**SERVICE BULLETIN**

**N° 189-256**

**ATA 71 – ENGINE COWLING LATCH RETROMOD**

**ENGINE COWLING LATCH RETROMOD  
8G7110P02311**

**Figure 1**

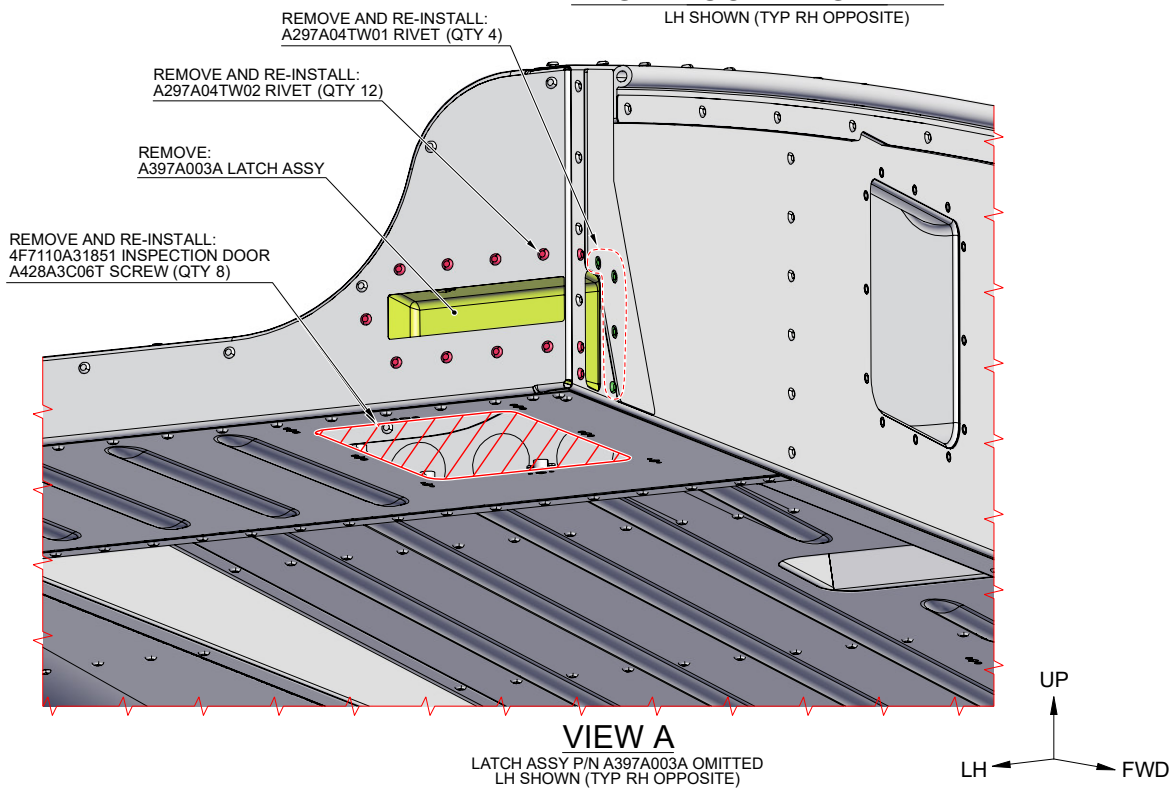
Leonardo Helicopters received reports about damages to the engine cowlings caused by an interference between the latches, when they are in fully opened position, and the cowling structure. The damage can be caused in case the latches were operated with excessive force.

Leonardo Helicopters developed a retromod to replace the existing engine cowlings rear latch boxes. The replacement is intended to repair existing damages and to prevent further occurrences to the engine cowlings rear latch box. The retromod gives all the necessary instructions on how to remove the damaged part of the cowling rear latch box assy and to install a new box with a different design, which does not allow any possibility of interference with the latches (also in fully opened position).

- 2.1.2 In accordance with AMP DM 89-A-06-41-00-00A-010A-A and with reference to Figure 1 View A, remove and retain n°8 screws P/N A428A3C06T and the inspection door P/N 4F7110A31851 (Access panel 461E) from the LH engine cowling assy P/N 4F7110A21232 or P/N 4F7110A21231.

- 2.1.3 With reference to Figure 1 View A, remove n°12 rivets P/N A297A04TW02 and n°4 rivets P/N A297A04TW01 from the LH engine cowling assy P/N 4F7110A21232 or P/N 4F7110A21231.

- 2.1.11 With reference to Figure 1 View A and Figure 2 Section B-B, install on the LH engine cowling assy P/N 4F7110A21232 or P/N 4F7110A21231 the LH rear latch box P/N 8G7110A22151 and the related support by means of n°12 rivets P/N A297A04TW02 and n°4 rivets P/N A297A04TW01.

- 2.1.12 In accordance with AMP DM 89-A-06-41-00-00A-010A-A and with reference to Figure 1 View A, re-install the inspection door P/N 4F7110A31851 (access panel 461E) on the LH engine cowling assy P/N 4F7110A21232 or P/N 4F7110A21231 by means of the n°8 screws P/N A428A3C06T previously removed.
